**APPLICATION FOR PERMISSION
UNDER SECTION 16 OF
THE TOWN PLANNING ORDINANCE
(CAP. 131)**

(a) Proposed use(s)/development 擬議用途/發展	Proposed Temporary Warehouse (Excluding Dangerous Goods Godown) with Ancillary Facilities for a Period of 3 Years and Associated Filling of Land (Please illustrate the details of the proposal on a layout plan) (請用平面圖說明擬議詳情)
(b) Effective period of permission applied for 申請的許可有效期	<input checked="" type="checkbox"/> year(s) 年 3 <input type="checkbox"/> month(s) 個月

SECTION 16 PLANNING APPLICATION

PLANNING STATEMENT

PLAN 11

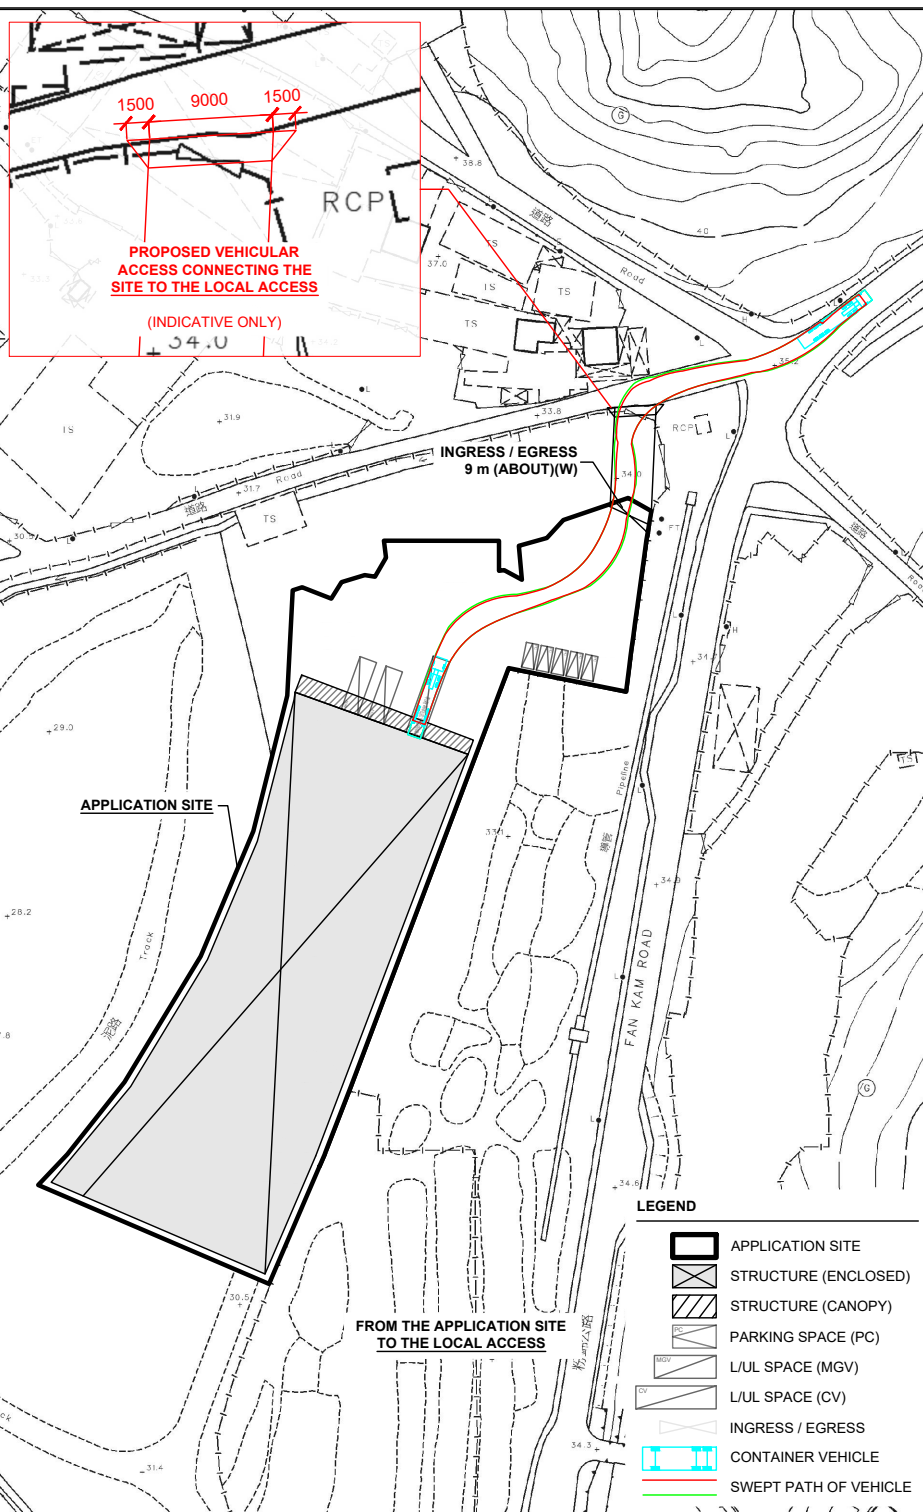
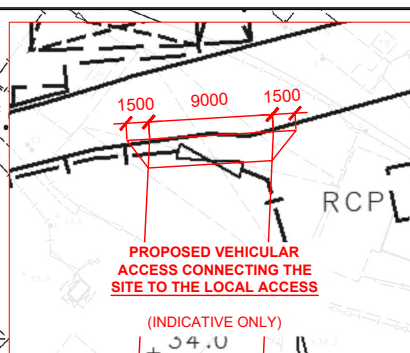
(a)	No consent is given for the proposed vehicular access via GL (as mentioned in the DRW No. PLAN 11 attached to the application form). The applicant should make his own arrangements for acquiring access to the application site. Any occupation of GL without Government's prior approval is an offence under Cap. 28.	The vehicular access indicated in Plan 11 of the submission will be demolished by the applicant after planning approval has been obtained from the Town Planning Board (the Board).

LANDSCAPE PROPOSAL

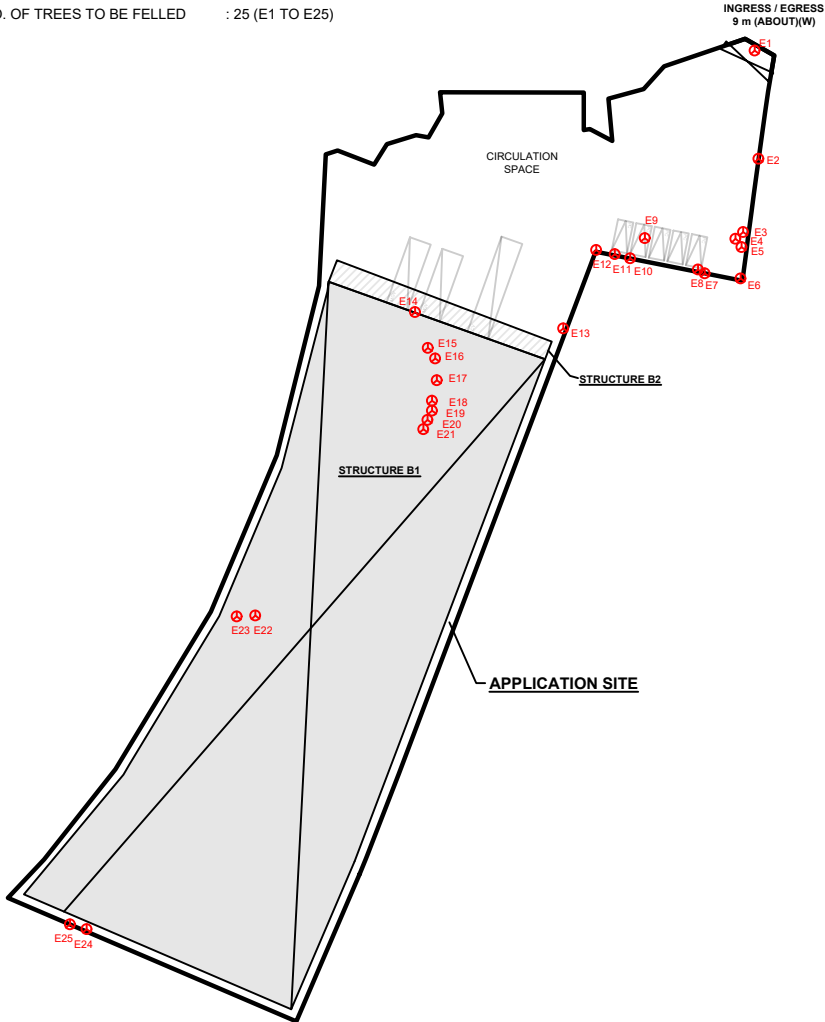
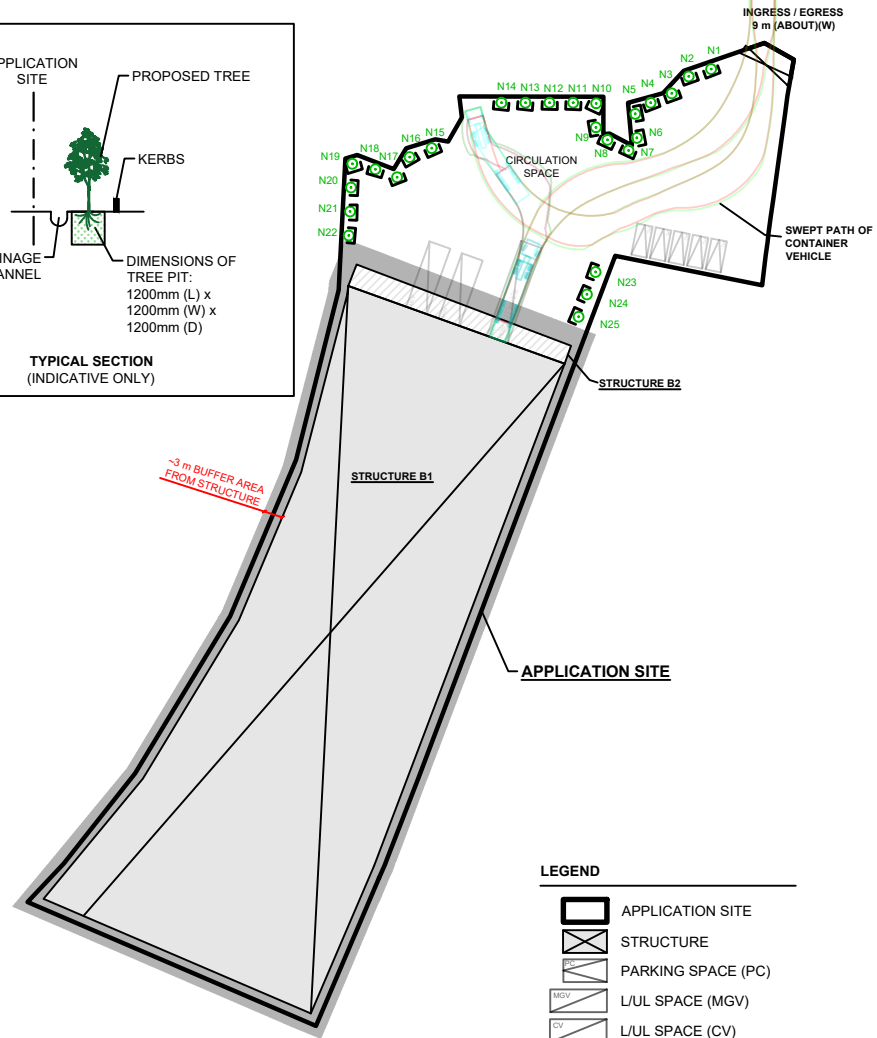
(a)	According to item 6(A) (e) (iii) of the Application Form, no tree felling would be caused by the proposed development. However, para 5.13 of the Planning Statement states that "...no existing tree is proposed to be preserved at the Site", and the proposed development layout, filling of land and swept path of vehicle shown on Plans 9 to 11 would be in conflict with the	According to the tree survey conducted on 11/2/2025, a total of <u>25</u> nos. of trees were recorded within the Site, within which no old and valuable tree or protected species has been identified in accordance with DEVB TC(W) No. 5/2020 – Registration and Preservation of Old and Valuable Trees and the Forests and Countryside Ordinance (Cap. 96) at the Site (Annex I). Due to proposed hard-paving works for erection of warehouse and vehicle

<p>existing trees. The discrepancies should be rectified.</p> <p>The applicant should provide survey on tree (with site photos showing the existing conditions) and illustrations on proposed changes and mitigation measures such as compensatory planting and/or other landscape treatments as appropriate.</p>	<p>circulation purposes, majority of the Site area will be disturbed; consequently, all existing trees within the Site will be affected, and it is not proposed to retain any of the existing trees at the Site.</p> <p>Due to felling of existing trees within the Site, a landscape proposal has been submitted by the applicant to provide landscape mitigation measures within the Site (Annex II). A total of <u>25</u> new trees is proposed to be planted along the northwest, north and northeast of the Site to minimize landscape and visual impact to the nearby areas. All the new trees will be maintained by the applicant during the planning approval period.</p>
